Technical Bulletin

Model: Mo-C2

No.: RD262004

Subject: Firmware Release Note: PowerSaving Sys			Prepared by: Y. Kurohashi
From: 1st PP Tech Service Sect., PP Tech Service Dept.			
Classification:	Troubleshooting	Part information	n 🛛 Action required
	🗌 Mechanical	Electrical	Service manual revision
	Paper path	Transmit/receiv	e Retrofit information
	Product Safety	Other (Firmwar	e) 🛛 Tier 2

Maintenance unit with newly-shaped filler:

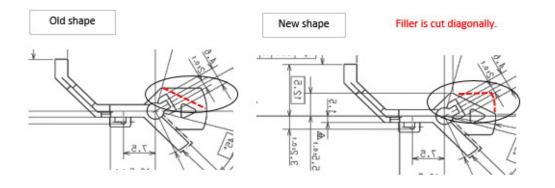
- (3) Touch the K2 cap lightly with your finger.
 - If the cap falls out of place very easily, replace the maintenance unit with the new one that contains a modified filler (See below).

The shape of the filler was changed so as to create more space between the filler and K2 cap holder.

New P/N: D2623504

P-to-P Revision

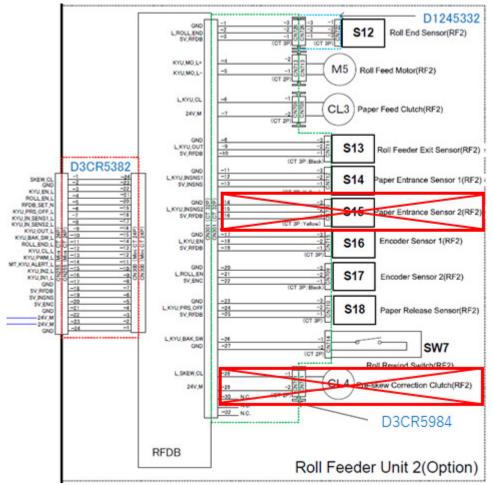
P to P diagram for Roll Feeder Unit 2 (Section: 9-10/ C-D) was corrected as follows.
